**CONDITIONAL APPROVAL**  
**PLAN APPROVAL EXPIRES: 08/09/2015**

Kwik Trip #328  
511 W 4TH St  
City of Blair, 54616  
Trempealeau County

Facility: 687216 KWIK TRIP #328  
511 W FOURTH STREET  
BLAIR 54616  
Plan Type: Addition-Alteration; 1 Interior Fixture(s)

Object Type: Commercial Water Treatment Device Regulated Object ID No.: 1442433

KWIK TRIP - SYSTEM LAYOUT	
DWG #	73-KWIK TRIP - LAYOUT
7-25-13	
dwg by:	J.VAACK
Approved by	J.MCDONALD
Hellenbrand It's what you don't see that counts	
Waunakee, WI 53597 (608)849-3050

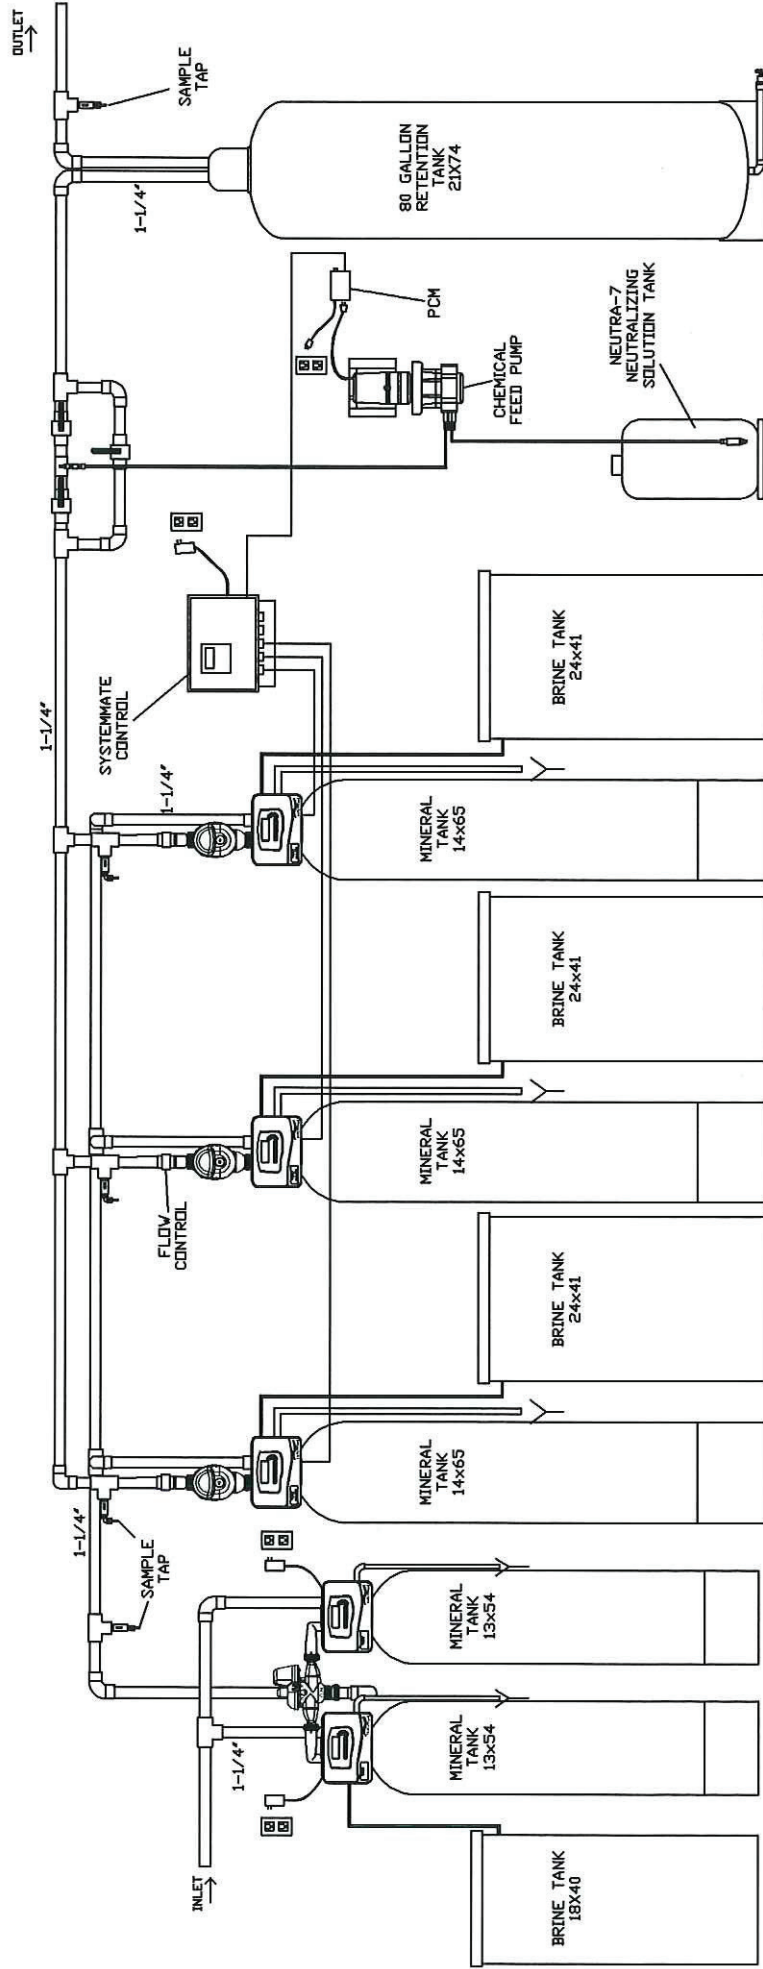
- Flow controls shall be installed to preclude each nitrate reduction device from exceeding its maximum rated service flow rate (i.e. 12 gpm).
- Any water treatment chemicals injected into the potable water supply shall conform to ANSI/NSF Standard 61.
- Any wall hydrant that is not served by the nitrate treatment device must have one, or more, of the following:
  1. The handles of the hydrant shall be removed;
  2. The hydrant shall be capped and sealed using solder; or
  3. Signage shall be posted immediately above the hydrant indicating the water is unfit for human consumption.
- All water distribution piping shall be marked as required by Table SPS 382.40-1a. This is in addition to any signage/labeling that may be required by the WDNR via a notification requirement or nitrate waiver.
